ECKERSON DESIGN ASSOCIATES
LANDSCAPE ARCHITECTURE

RE: Casazza Residence, 17 Brush Island Road, Darien, CT - Map# 56, Lot# 19

As the landscape architect for the Casazzas, I respectfully request your consideration of the following additions and alterations to the site plan.

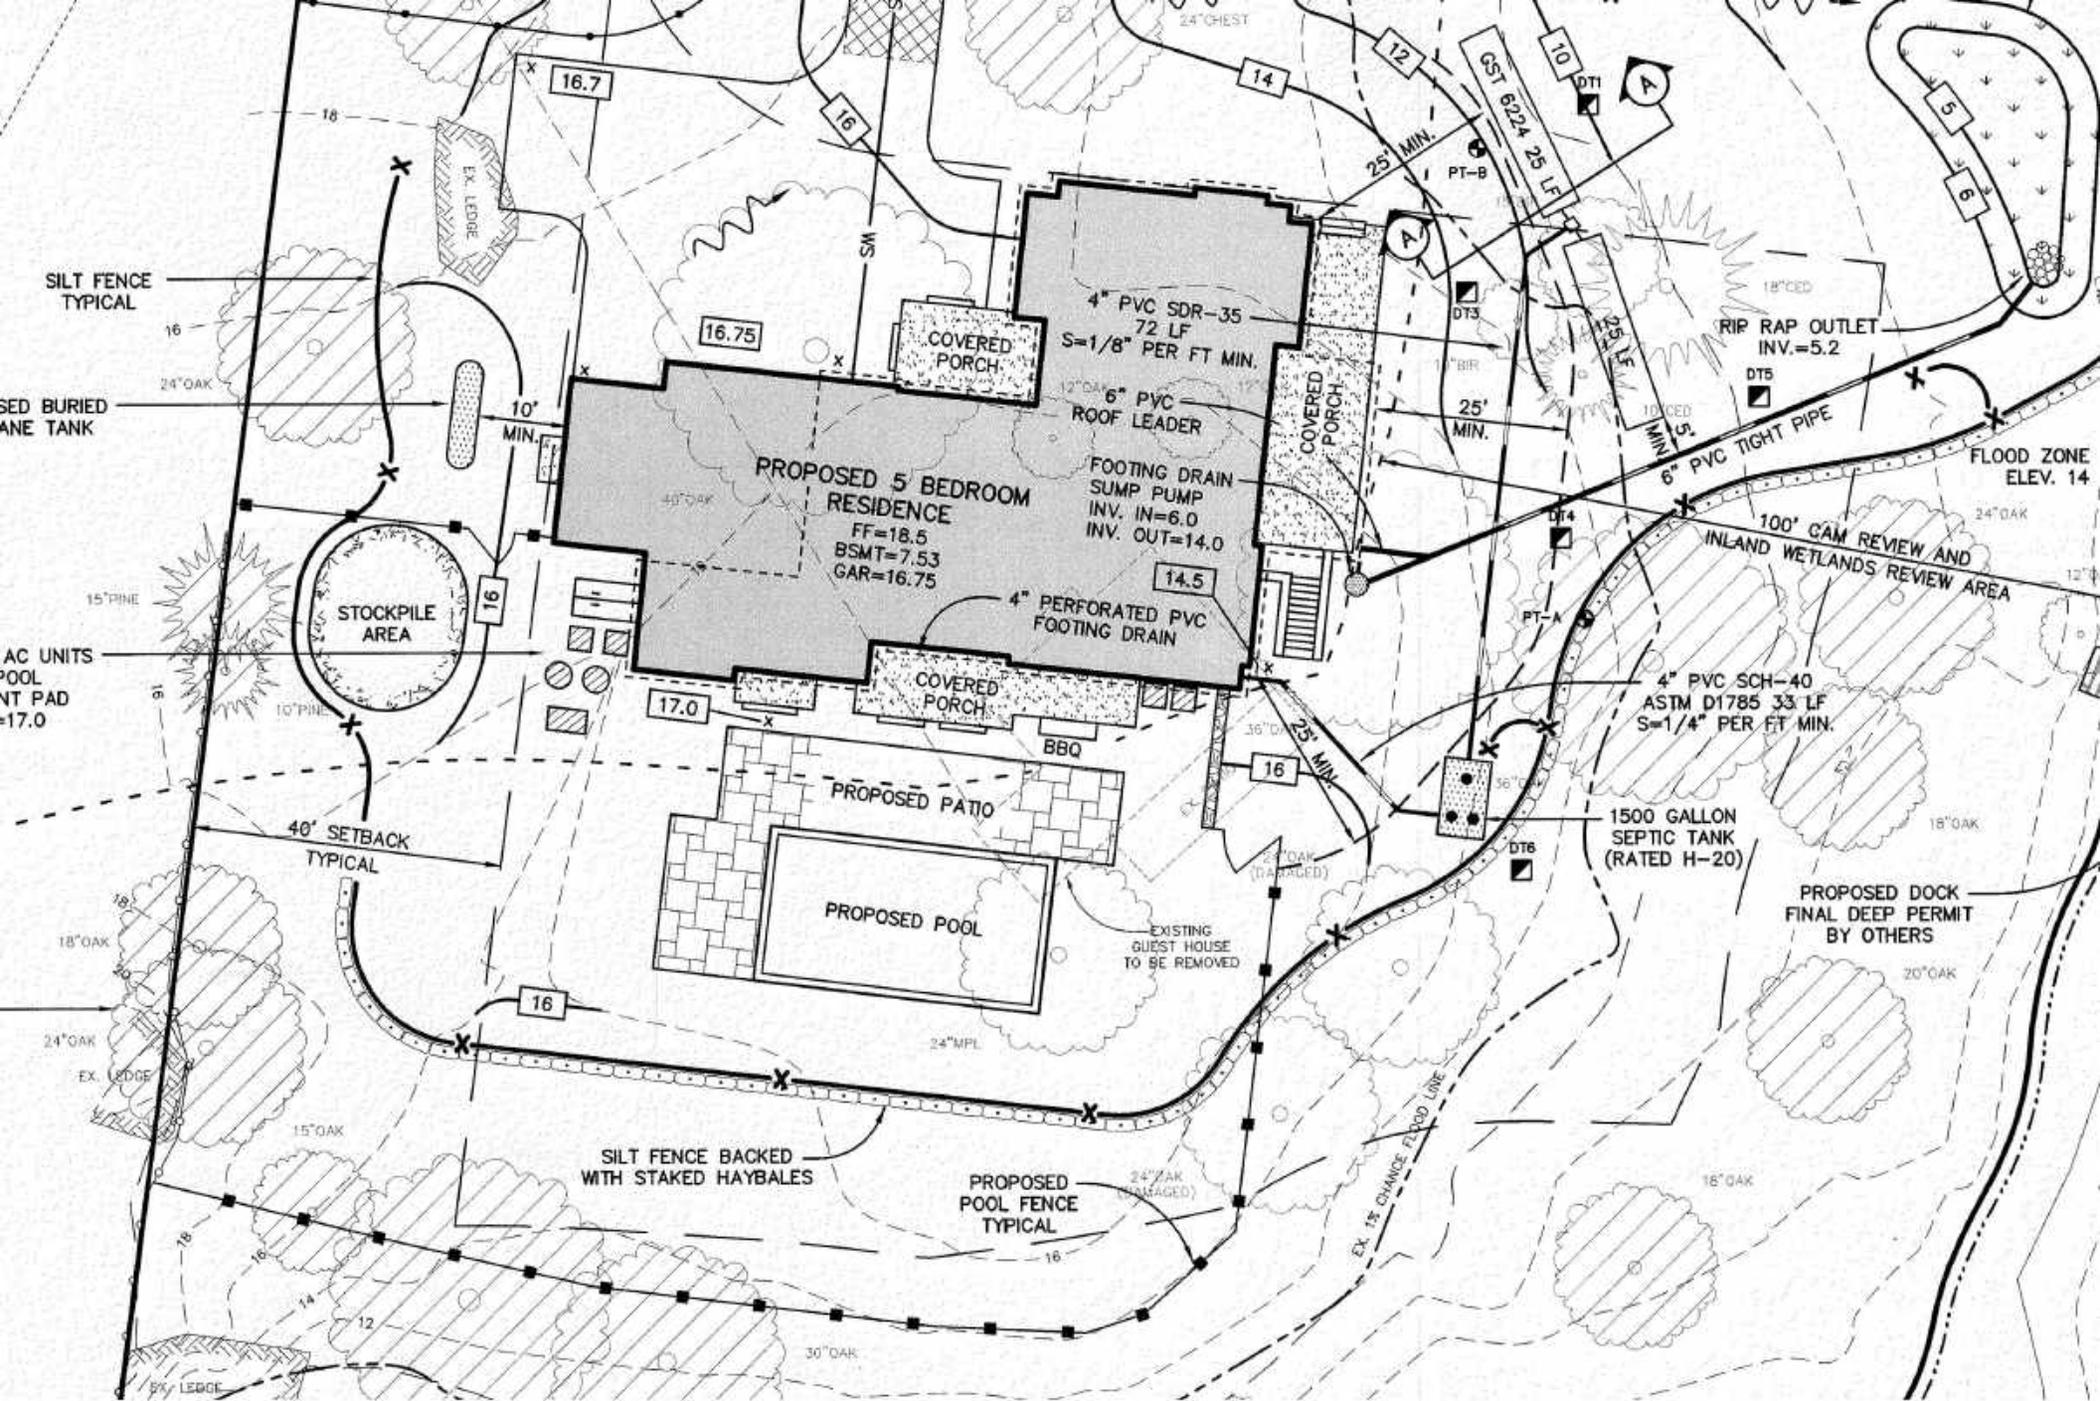
- 1) Stepping stone path from driveway to pool area
- 2) Artificial turf play area
- 3) Raised spa
- 4) Small patio expansion
- 5) Masonry firepit with surrounding patio
- 6) Redesign of low wall and steps

(6) Low Wall and Steps

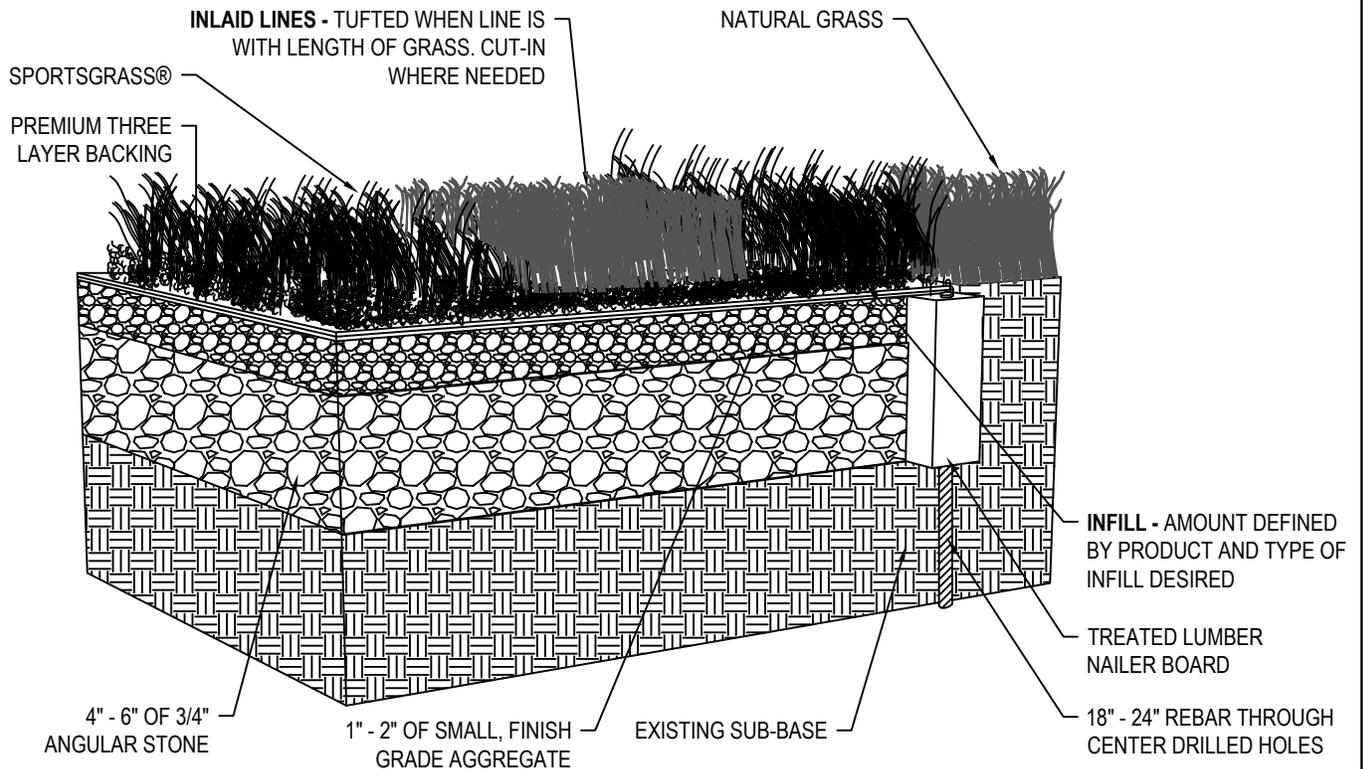
Large boulders currently form a low wall and steps at the northeast corner of the house. The boulders create an uneven surface and are placed awkwardly in the corner of the yard. We are proposing to replace the boulders with a low fieldstone wall and slab steps to create a safer path around the house. We are not proposing to change the grade at the top or bottom of the existing wall. We are just shifting the orientation of the wall and path.
